# CITY PLANNING COMMISSION

- APPLICATION:
1. Negative Declaration
  2. Amendment of the Valley Hi Community Plan from Light Density Residential to Medium Density Residential
  3. Rezone 12± acres from Single Family (R-1) to Medium Density Multiple Family (R-3)
  4. Special Permit to develop condominium units (P83-334)

PROPOSAL: The applicant is requesting the necessary entitlements to develop 252 condominium units on 12± vacant acres.

APPLC. NO. P83-334

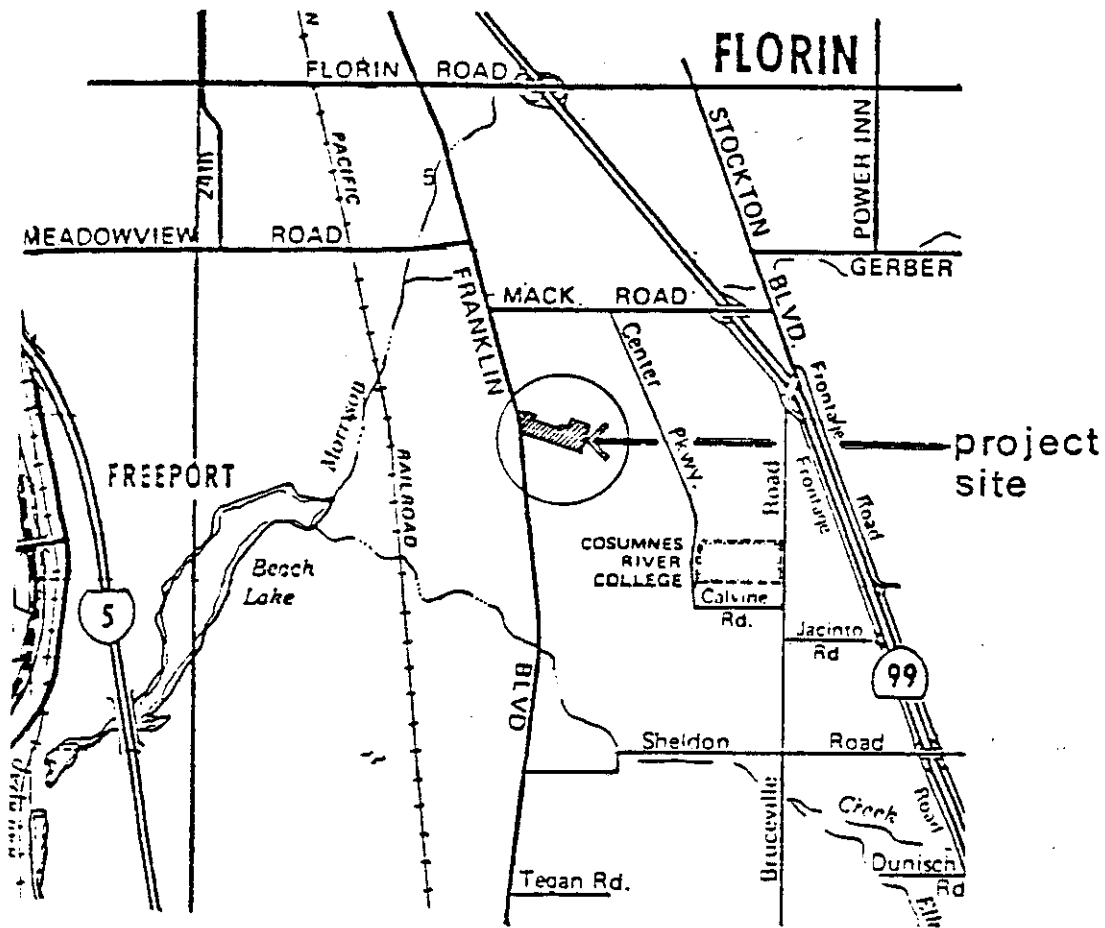
3. The site plan has been revised to accommodate the additional cluster types, as well as to increase the setback between the two-story condominium units and the patio home units to the east. Staff finds that additional setback is warranted between the remaining 12-unit cluster and adjacent single family as shown on Exhibit A. This additional setback can be achieved by rotating this cluster to parallel the private entry street. Also, staff recommends that the second story balconies be eliminated from these units.

5. In general, staff finds the amount and distribution of open space and landscaped areas as indicated in the site plan acceptable. However, staff recommends that thought be given to the addition of a design element to break up the long alleyways between the garages. This modification could be accomplished by incorporating additional planter areas, or by incorporating a pattern design into the pavement.

- a. The applicant shall relocate the 12-unit cluster as shown on Exhibit A to increase the setback between said units and adjacent single family units located to the east. The revised plans shall be submitted for staff review and approval prior to issuance of building permits;
- b. The applicant shall revise the site plan to incorporate additional design relief within the alleyways as indicated in Item 5 of staff evaluation. The revised plans shall be submitted for staff review and approval prior to issuance of building permits;
- c. The attached Residential Design Criteria shall be adopted as conditions of approval;
- d. The applicant shall submit detailed landscape and irrigation plans for review and approval of staff prior to issuance of building permits;
- e. The applicant shall utilize the submitted plans.

ELEVATIONS FOR PLAN TYPES A & B

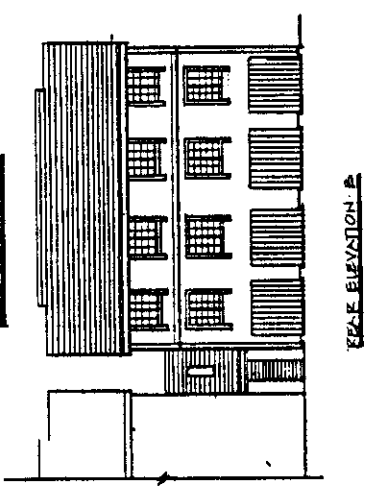
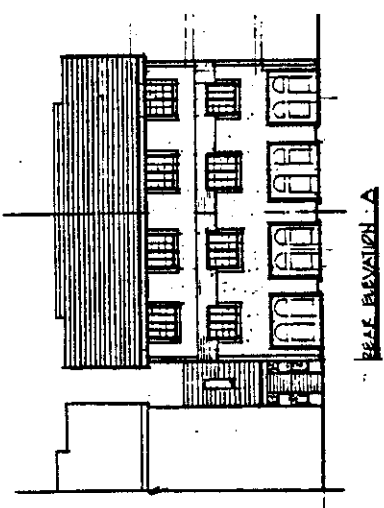
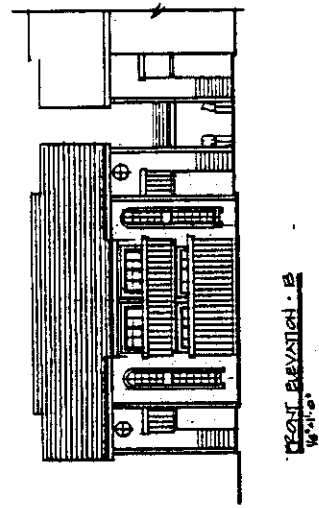
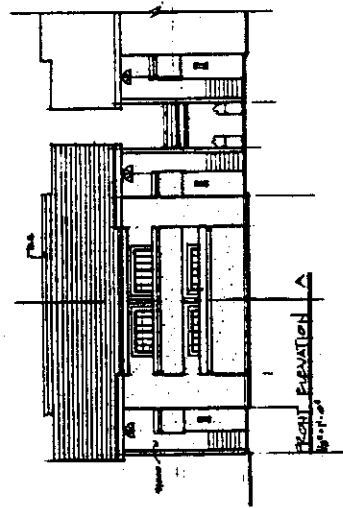
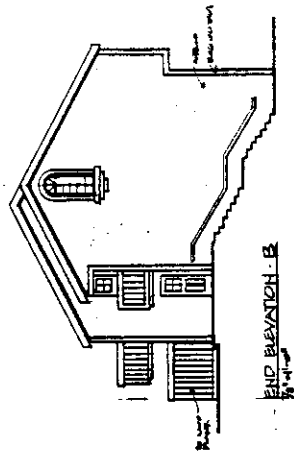
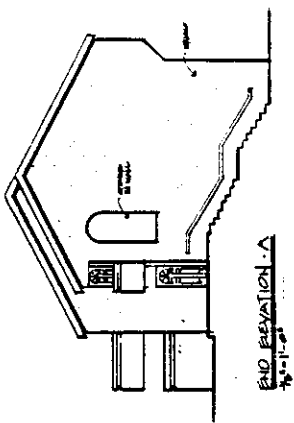
4. The original project utilized only one cluster-type for the entire project. The exterior elevations indicated that plywood siding with wood trim and shake roofs were to be utilized. The current project indicates that five cluster types will be utilized throughout the project. Also, the architecture of the project has been changed to Mediterranean/Spanish Revival with the use of stucco exterior with tile roofs. Staff finds the proposed unit types and overall design a vast improvement over the original project.
